Bulls Eye Home Inspection, PLLC

Phase Inspection Report

Pre-Drywall Checklist

Tape around pipe penetration

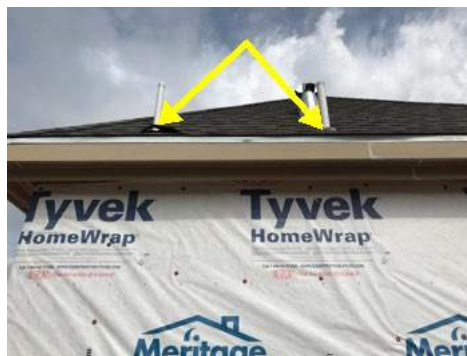
Holes/tears were observed in the weather resistive barrier. We recommend having them repaired per the manufacturer's instructions. See section R703.2. This was noted on the
